DART SERVICE INSTRUCTION

TO AMEND INSTALLATION INSTRUCTIONS D350-567 REV. C

REF. CANADIAN STC: SH92-18 REF. FAA STC: SH989NE/SH990NE

DESIGN	DRAWN BY	DART AEROSPACE LTD HAWKESBURY, ONTARIO, CANADA	
CHECKED	APPROVED	DRAWING NO. DSI 9282	REV. A
DATE	171	TITLE	SCALE
04.06.21		REPLACEMENT WINDOW KIT	NTS

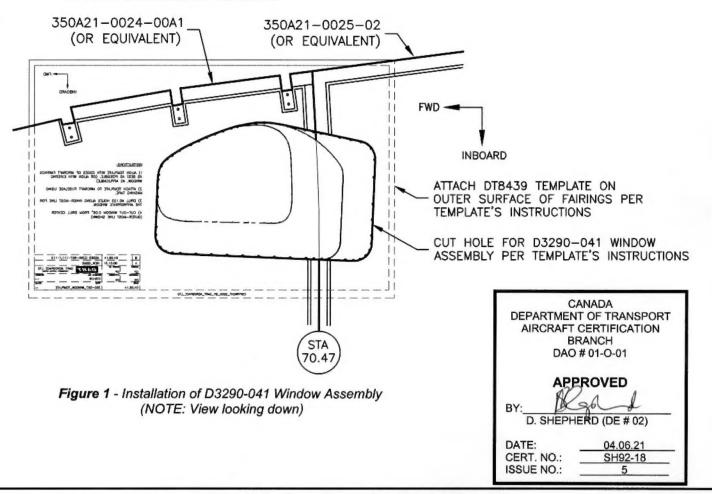
To install the D350-567-113 kit: Use drawing DT8439 as a template to mark the location of the D3290-041 window assembly as shown in Figure 1. The instructions for the use of DT8439 are on the drawing itself. Be sure to use the outline of the D350-567-113 window.

FIGURE 2 - FLOOR WINDOW INSTALLATION

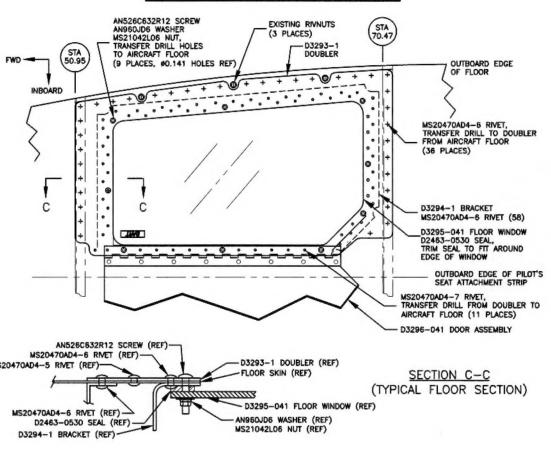
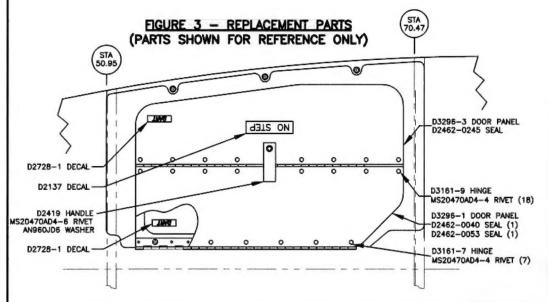
- Install the D3290-041 Window Assembly per Section 3.5 (page 11) of Installation Instructions D350-567 Rev. C. Note that D3290-041 replaces D2942.
- 3) To install the D350-567-115 kit: Install the D3295-041 Floor Window per Section 3.5 (page 9) of Installation Instructions D350-567 Rev. C using the hardware shown in Figures 2 and 3 of these instructions (DSI9282 Rev.A). Note that D3293-1, D3294-1, D3295-041, & D3296-041 replace D2949, D2959, D2951, & D2950-041 respectively.
